## Notes on technical issues for the vibration assessment for the Chiltern Line Upgrade through Wolvercote

Figure 2. Simple calculation of relative vibration responses to a constant amplitude (unit) load at 10 m.

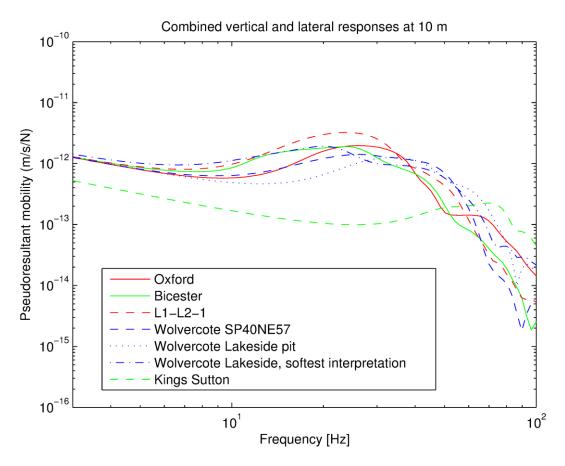
The Oxford, Bicester and Kings Sutton responses are those presented in my notes made for the LPAs in February 2013. The significantly lower response at King Sutton means that a prediction scheme based on these measurements would likely predict levels of vibration below what could be expected alongside the Bicester - Oxford line. In comparison to this the curves representing locations closer to the Oxford - Bicester line are much closer together. They all come together at very low frequency because, at low frequency, the vibration transmission depends on the deeper situated material and I have seen that throughout the whole area the ground becomes the same stiff Oxford clay at some depth. No other, much deeper, rocky material is expected to have influence in the frequency range we are interested in.

For Wolvercote, within that line, specifically I have made three calculations. One based on my best interpretation of the SP40NE57 bore hole and two, more uncertain in interpretation, based on the lakeside pit information (SP41SE157); a 'best' interpretation and one that errs on the side of assuming soft materials.

For the L1/L2 site the borehole information is clear but I have erred on the side of caution by assuming a compacted gravel shear wave speed for the gravel layers that are labelled as river terrace deposits. A higher response is indicated at the L1/L2 site over most of the frequency range. Only the more pessimistic interpretation of the Lakeside data exceeds this slightly.
